Enclosure 2

Response to NRC Request for Additional Information 350

RAI Package 350, Question 410

Kairos Power Response

Figure 1

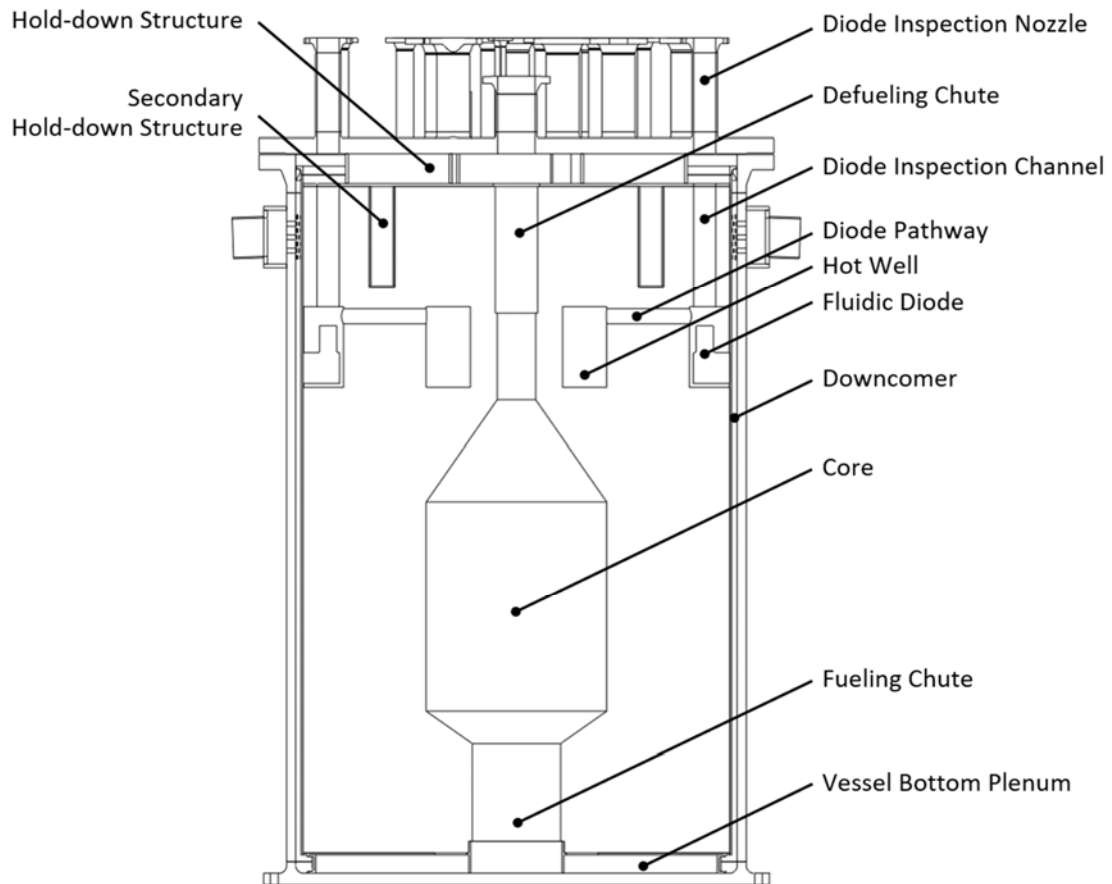
Describe how component integrity is ensured if the duration of an air ingress event is longer than the duration covered by the materials qualification testing.

The graphite reflector blocks that are located above the free surface of the Flibe are subject to potential oxidation effects during a postulated air ingress event. Since the shutdown elements insert at the beginning of the event, this exposed graphite structure is not credited after insertion to perform a “long term” structural integrity safety function when oxidation could begin to affect the structural integrity. Additionally, if significant oxidation were to result in a loss of structural integrity of the exposed graphite, there is a layer of submerged (Flibe-wetted) graphite that mitigates debris from the exposed graphite from entering the natural circulation flow path.

As shown in Figure 1, the secondary hold-down structure is installed within the upper layers of the graphite reflector and extends below the minimum Flibe level for a PHTS break event. If significant oxidation were to result in a loss of structural integrity of the graphite above the minimum Flibe level, the secondary hold-down structure will transfer loads from the submerged graphite to the top head, keeping the remaining reflector structure in place and submerged in Flibe. The effects of non-forced air ingress on the integrity of components below the surface of Flibe will be bounded by the materials qualification testing programs for at least seven days following the initiation of the event. Beyond seven days, defense in depth features include: implementing repairs on damaged SSCs, replenishing argon supply, or removal of fuel from the vessel. This ensures that the geometry of the core and the natural circulation flow paths are maintained. PSAR Section 4.3 has been updated to remove the statement the reactor vessel is designed to preclude air ingress and to reflect the secondary hold-down structure design details described above. PSAR Section 13.1.10.5 has been updated to describe defense in depth features of the design available after the initial seven day period of a postulated air ingress event. A markup of changes to the graphite qualification topical report providing additional details of the of the assessment of air ingress on the integrity of components below the surface of Flibe is being provided with this response. A revision to the graphite qualification topical report will be submitted by separate letter.
